UNITED STATES PATENT AND TRADEMARK OFFICE

APPLICATION NO.	FILING DATE	FIRST NAMED INVENTOR	ATTORNEY DOCKET NO.	CONFIRMATION NO.
10/625,786	07/24/2003	Gerd Stahlecker	010971.52513US	8184
23911	7590	09/02/2004	EXAMINER	
CROWELL & MORING LLP INTELLECTUAL PROPERTY GROUP P.O. BOX 14300 WASHINGTON, DC 20044-4300			PATEL, VISHAL A	
			ART UNIT	PAPER NUMBER
			3676

Office Action Summary	Application No.	Applicant(s)	
	10/625,786	STAHLCKER, GERD	
Examiner	Art Unit	Vishal Patel	3676

DETAILED ACTION

Fig. 2

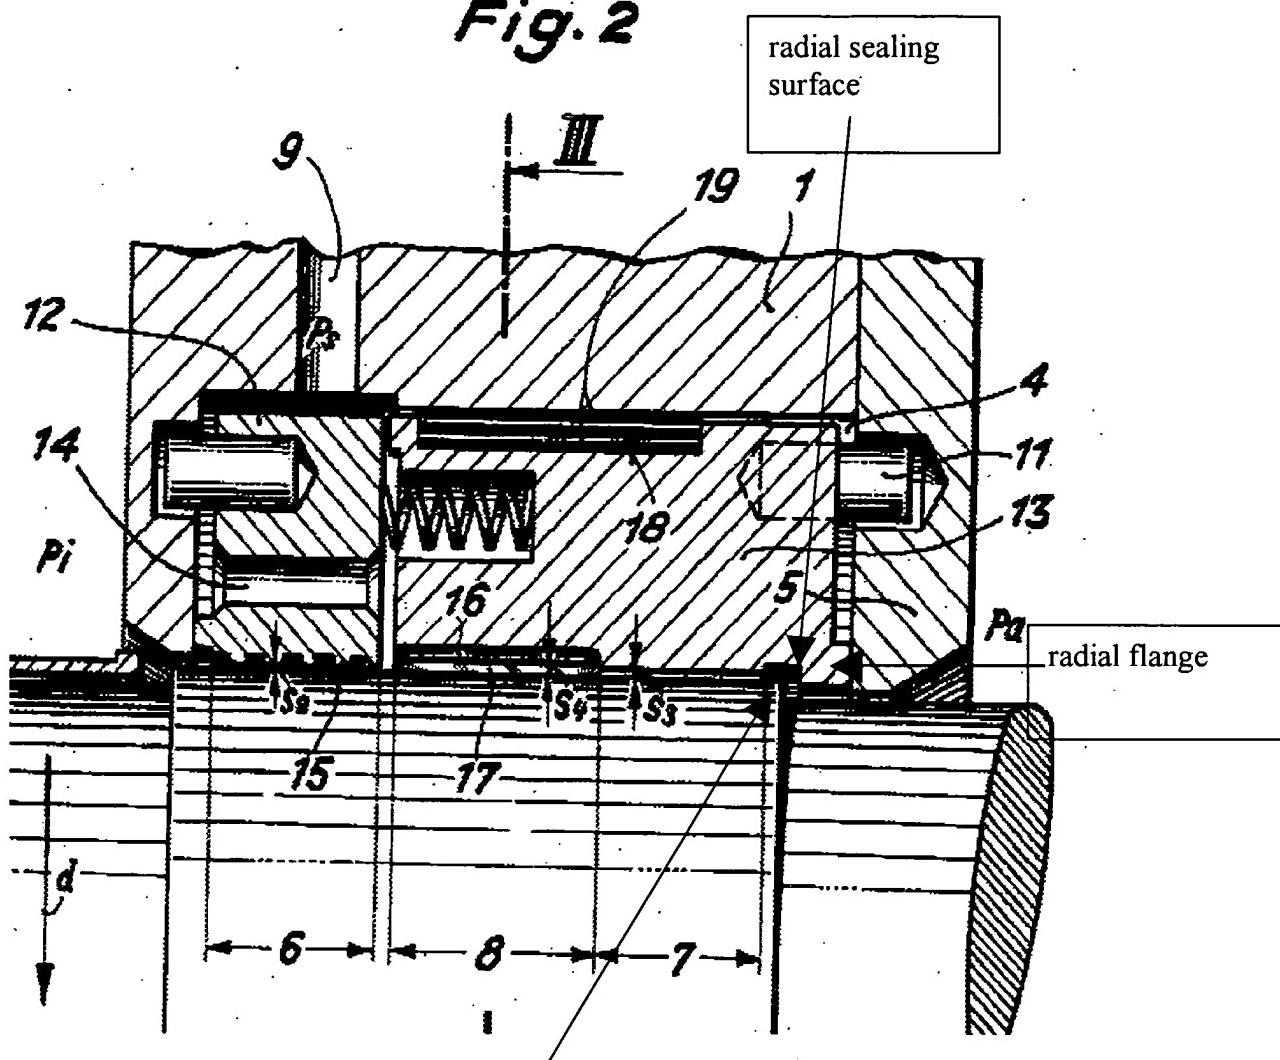
Regarding claims 1 and 22: Strub discloses an arrangement *for sealing an opening of a rotor housing in which a vacuum prevails, through which opening a shaft, supported outside of the rotor housing, projects (intended use)*. The arrangement comprising at least two sealing gaps (first sealing gap between the shaft 2 and portion of 13 that is right of S3 and second sealing gap

S3), of which a first sealing gap (gap formed between the shaft 2 and portion of 13 that is right of S3) is formed between the shaft (2) and a sealing element free floating (13) and a second sealing gap is formed with a ring collar (ring collar that forms the gap S3) of the spinning rotor bordering on the shaft (2). The second sealing gap is also formed with the same free floating sealing element (13). The sealing element free floating is a unitary sealing element.

Regarding claims 2 and 23: The sealing element comprises a radial flange (radial flange of 13 that contacts 5) and is disposed on an also radially aligned support surface (radial surface of 5) of the rotor housing (housing formed by 1 and 5) and which comprises a tube-like area (tube-like area of the sealing ring that forms the gap S3) arranged at the collar of the shaft.

Regarding claims 3 and 24: The radial flange is pressed to the support surface by at least one spring element (spring element pushing the sealing element toward the support surface, figure 2).

Regarding claims 4-6 and 25: The sealing element comprises an essentially radially extending sealing surface (radial sealing surface) which together with a rear wall (rear wall) of the spinning rotor forms a third sealing gap (gap between the radial sealing surface and the rear wall).

Regarding claims 10-12: The sealing surface is arranged as an exchangeable part, which is connectable to the sealing element (this would be the case since the ring 13 is capable of being replaced and the sealing surface is able to be connect to the sealing element since both are formed as a single member).
